5 November 15

Shotover Country Limited  
C/o Clarke Fortune Macdonald and Associates Ltd  
Po Box 553  
Queenstown

50295 SHOTOVER COUNTRY SHA GEOTECH  
REVIEW OF LIQUEFACTION POTENTIAL FOR SHOTOVER COUNTRY SPECIAL HOUSING AREA.

Investigation Plan  
**INVESTIGATION PLAN**

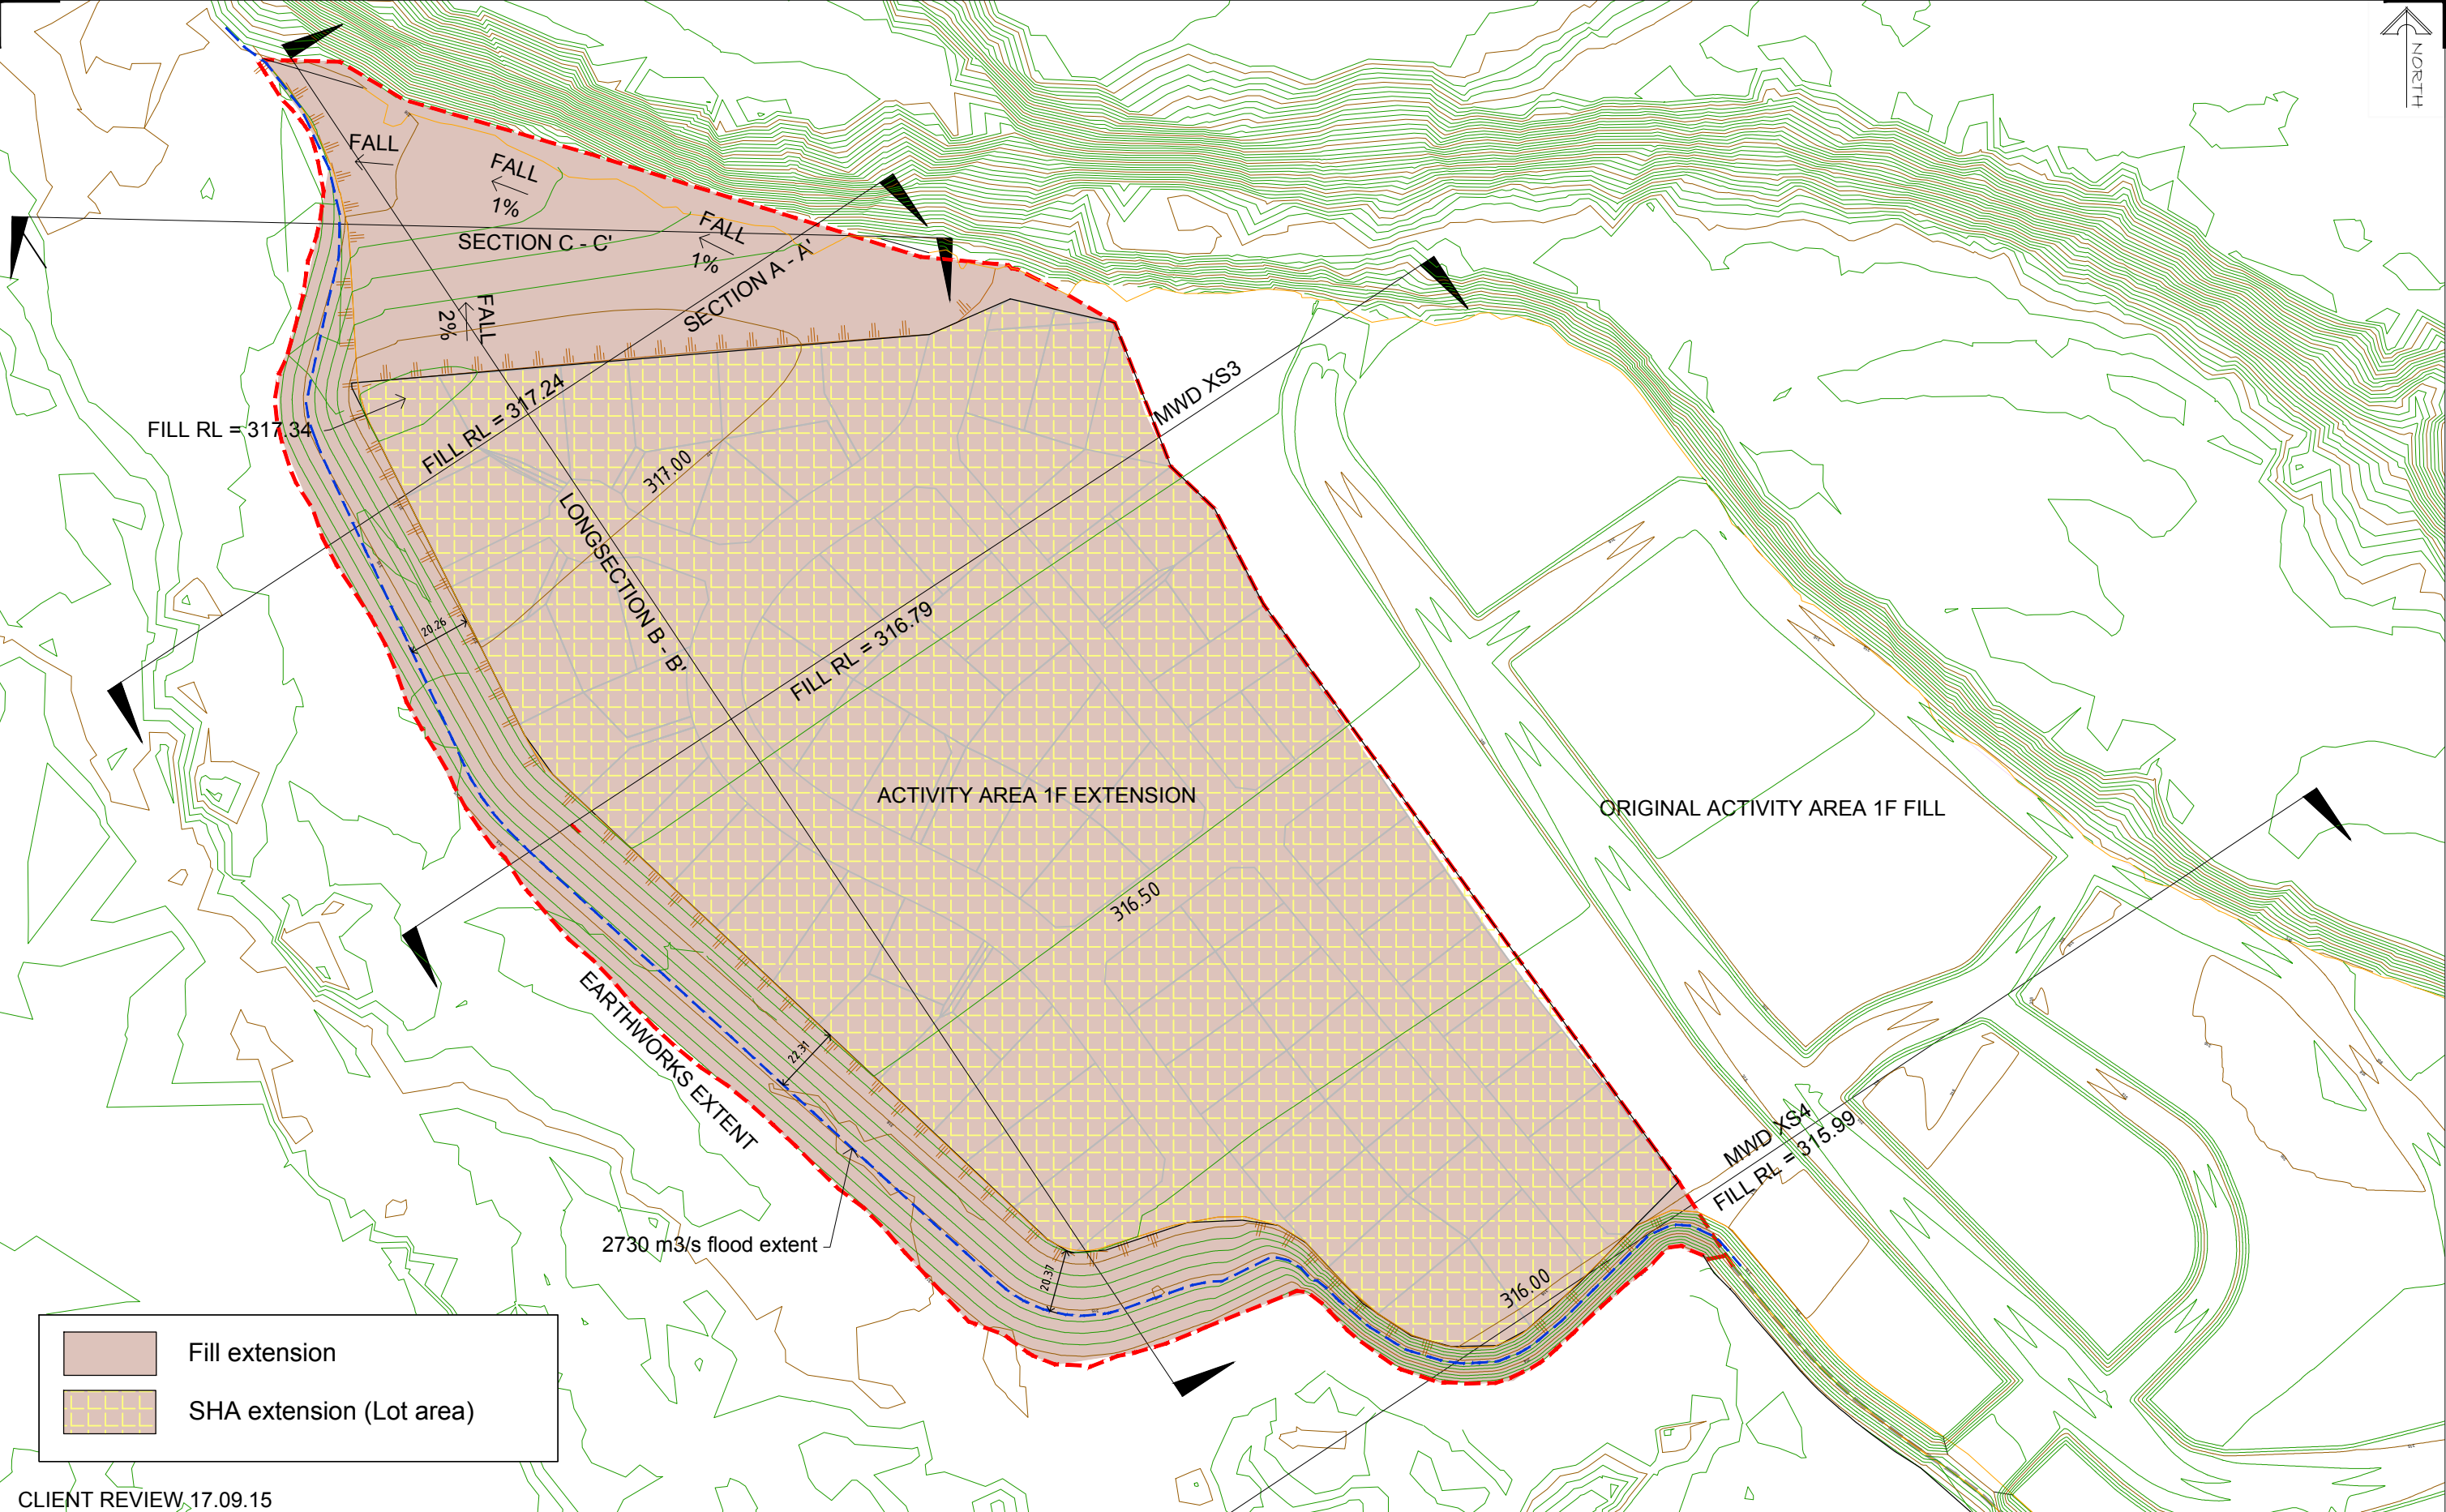
Stereopair aerial photos display an anomalously proud ridge and adjoining areas at the east side of the tread. (Reference annotated Bryant plan.) I suspect this is an aeolian deposit (i.e. wind blown – saltation and aerial) that originated on the Shotover floodplain during earlier degradation. As such, it may be largely sand/silty sand, but it should be dry and not, therefore, subject to liquefaction.

## SPECIAL HOUSING AREA FILL EXTENSION - SECTIONS

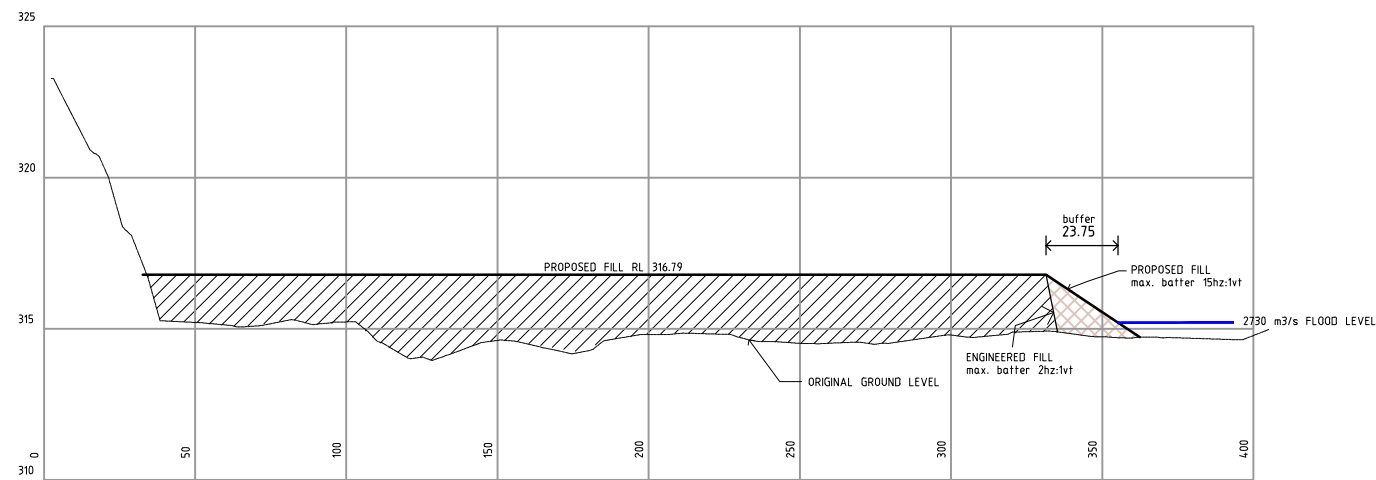
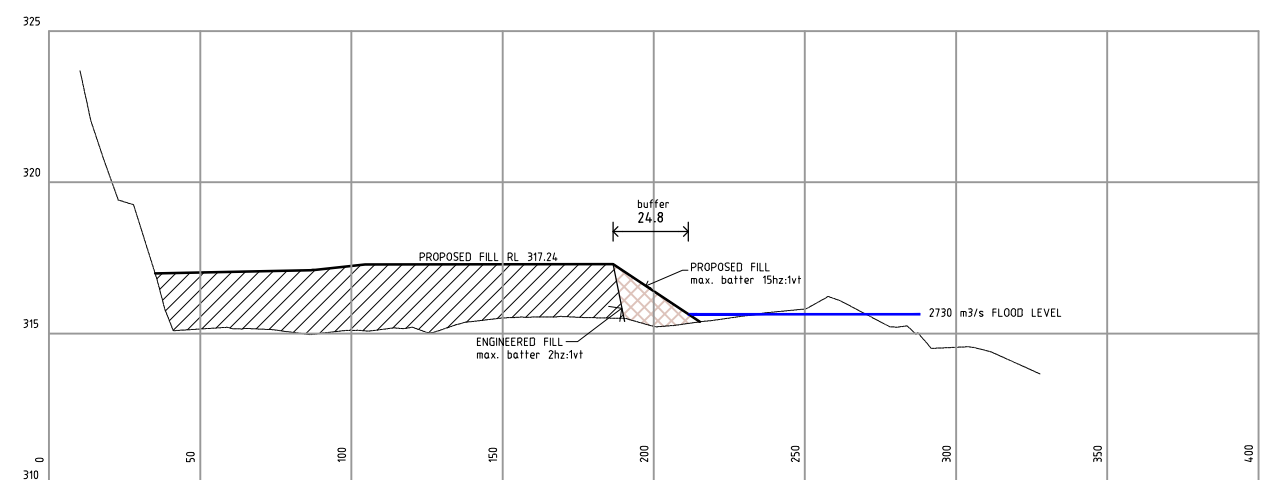
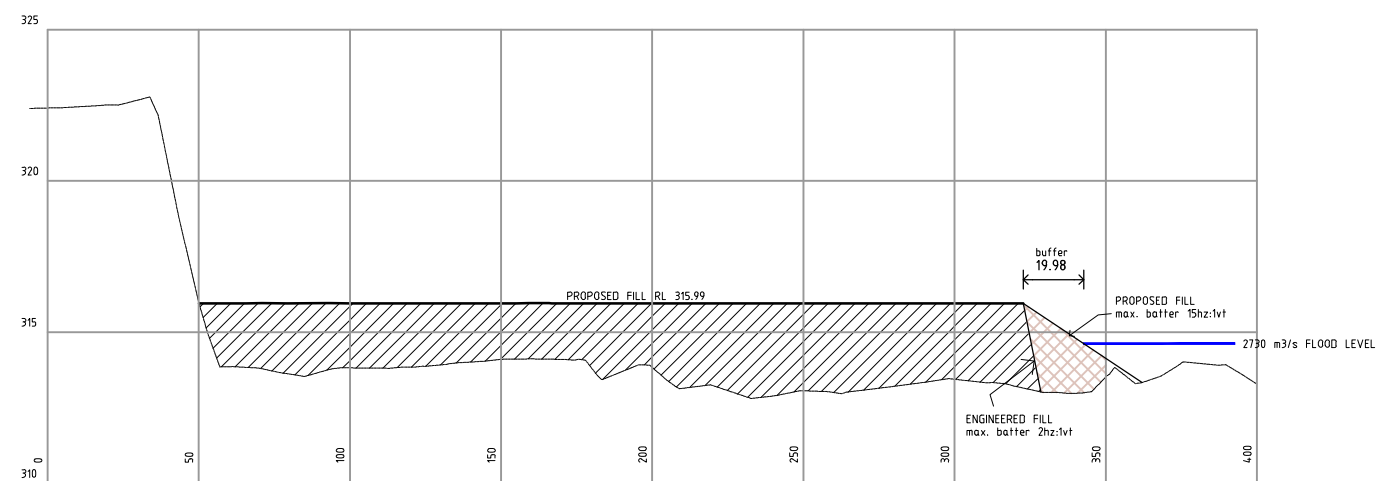
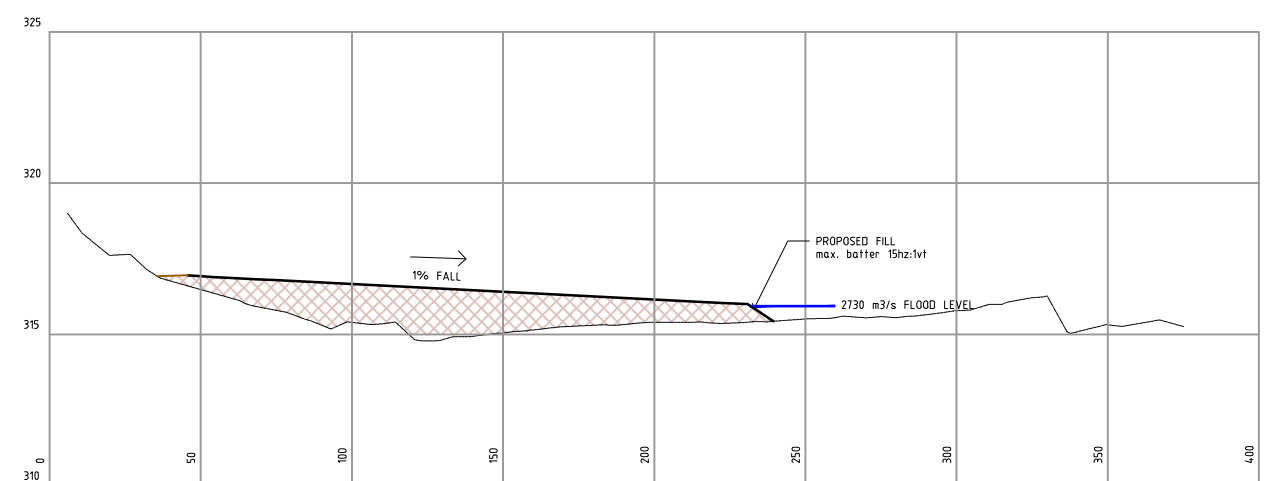
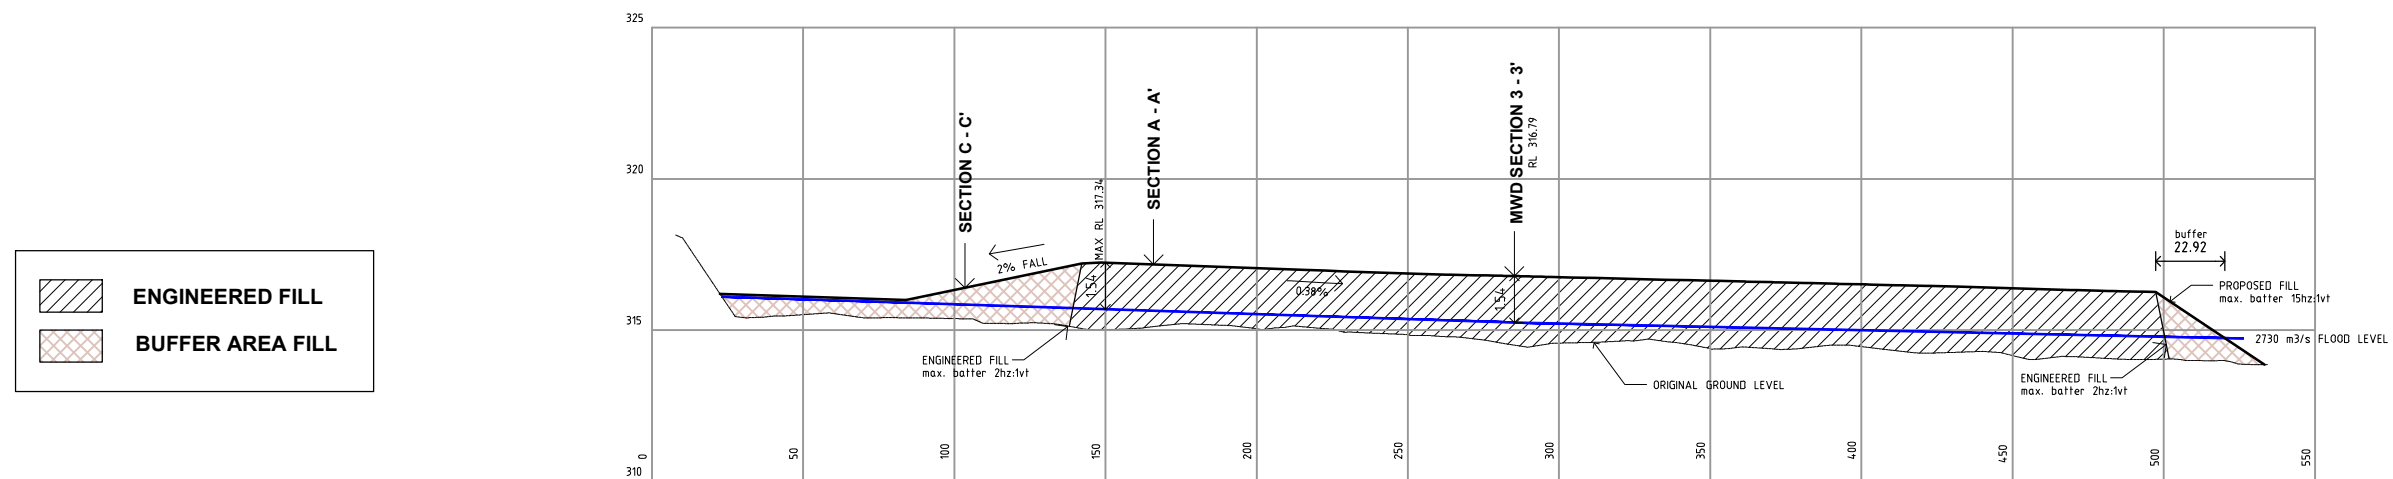
Design drawings: The subdivision design drawings show a very large fill importation operation with a nominal 2.5m of fill to be placed across the entire site.

If liquefaction was a potential hazard then one of the most likely solutions for mitigating its effects on the proposed SHA would be for a thick gravel raft such as the proposed.

The proposed fill extents would also be expected to be a suitable mitigation and remediation measure if in the unlikely event liquefaction is found to be a possibility of affecting the SHA area. However this would be detailed by the Geoprofessional for the site in the reporting to be provided as part of the main resource consent application to QLDC.
